Bulletin No: 562-80007-00
 Issued: September 4, 2007

Subject:	Pilot Valve Replacement
-----------------	-------------------------

Model Numbers Affected:	NTF-15 Plus & NTF-60 Plus
Manufacture Dates:	All
Serial Numbers Affected:	All
Tools Required:	As Required
Parts Required:	Pilot Valve: P/N 022-80135-00 (Shown in photo below) Replacement Kit: P/N 355-80098-00 (Includes 022-80135-00 and this document explaining installation).
Supplemental Document:	None
Action Required:	Ensure Pilot Valve is installed properly and that plastic plug is removed from the proper port.

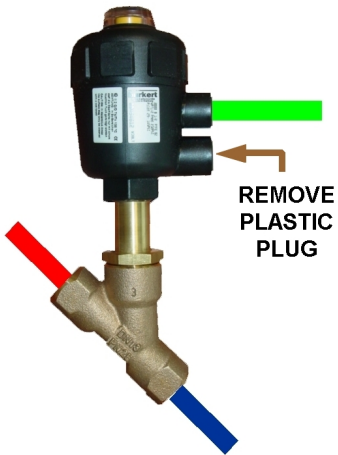
Replacement of the Pilot Valve requires special attention to the three lines which connect to it and...

**MOST IMPORTANT
 THE PLASTIC PLUG
 MUST BE REMOVED**

The photos show the correct connection of the Pilot Valve and the important requirement of removing the plastic plug from the port which has no connection.
